**Re: Comments for the Bureau of Ocean Energy and Management's Draft  
Environmental Impact Statement for the Vineyard Wind Proposed Wind Energy  
Facility, Docket Number BOEM-2018-0069**

**ATTACHMENT A**  
**National Marine Fisheries Service's Comments on**  
**BOEM's Draft Environmental Impact Statement (DEIS) for the**  
**Vineyard Wind Offshore Wind Energy Project (BOEM 2018-0069)**

**Figure 1: VMS fishing effort (0-5kts) for Atlantic Mackerel, Squid, and Butterfish trip declarations, 2010-2018. The Vineyard Wind Lease Area is outlined in red.**

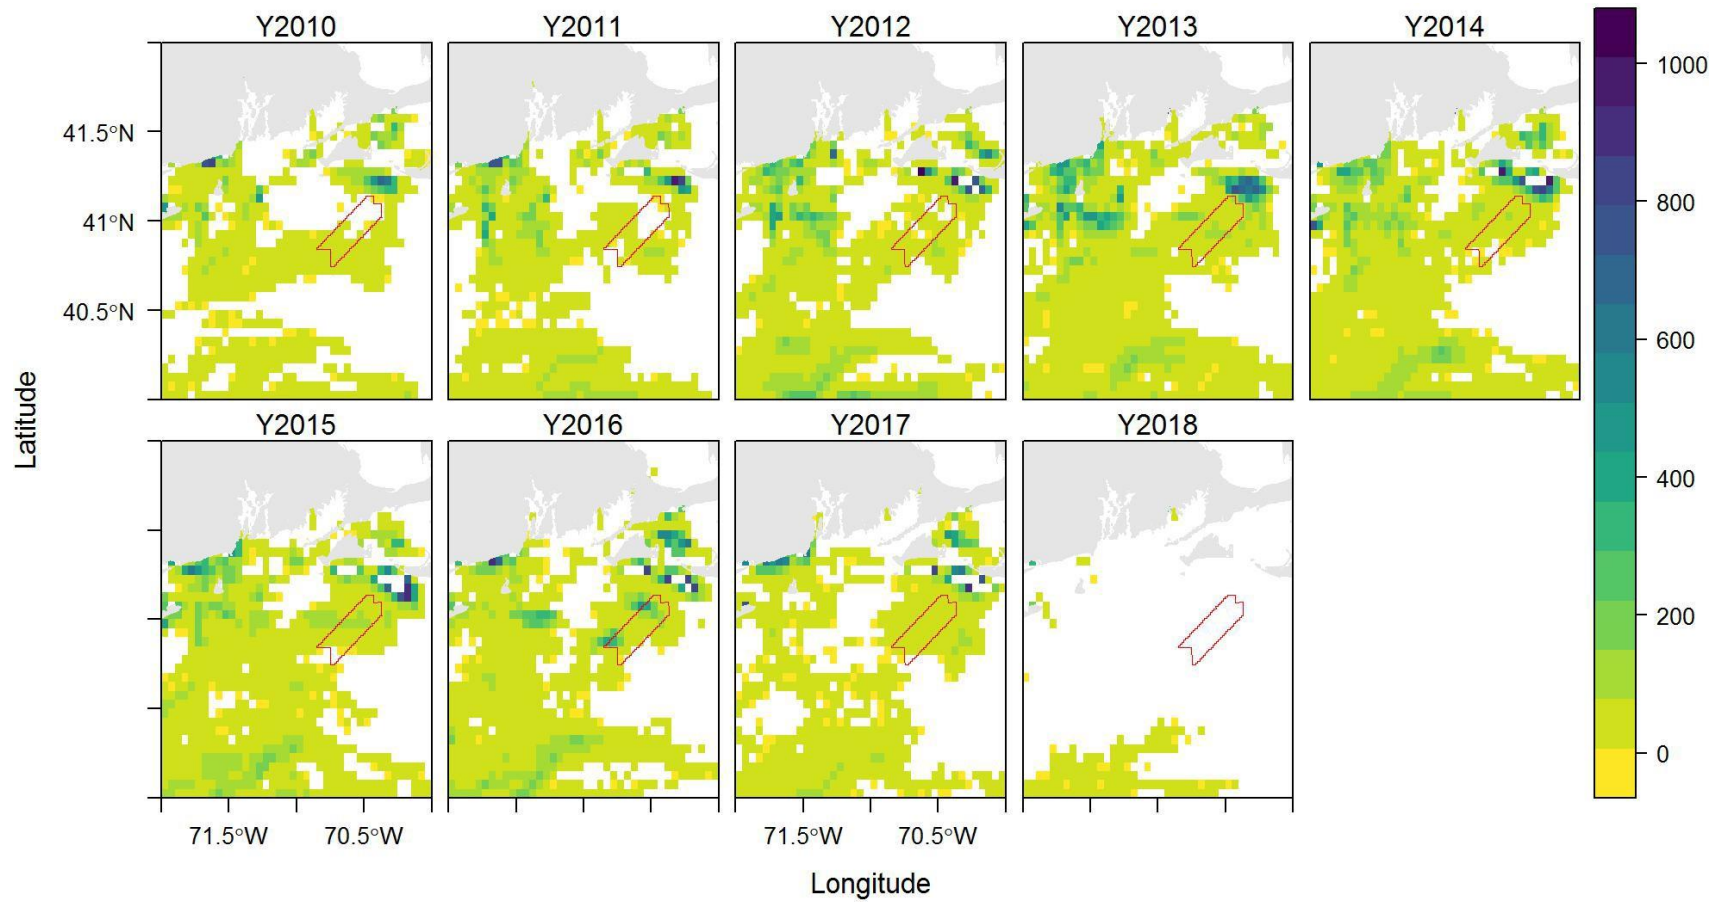
The Vineyard Wind EIS provided landings from 2011-2016, which are markedly different than those shown here.
